SUBJECT: Hyundai ImageQuest Co., Ltd.

FCC ID: PJIL19C0D072  
Class II Permissive Change  
Orig. Grant Date : June 09, 2005

Transmitted herewith, on behalf of Hyundai ImageQuest Co., Ltd. is an application for a Class II Permissive Change Certification of the following 19-inch LCD Monitor:

FCC ID : PJIL19C0D072  
Model/TYPE : L90D+/ L19C0D072

## • Solution for EMI

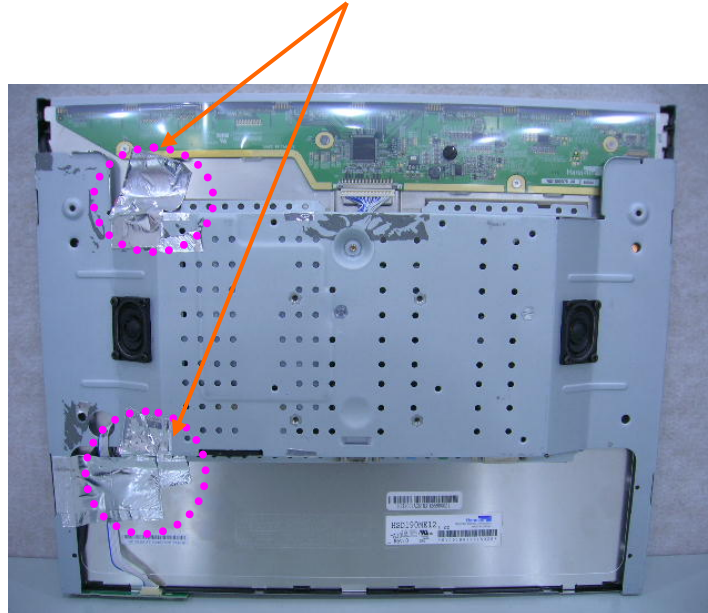
**1. Attach aluminum tape on the frame and LCD Rear panel.**

**2. Attach a gasket on the main frame and main board to contact the LCD Rear panel**
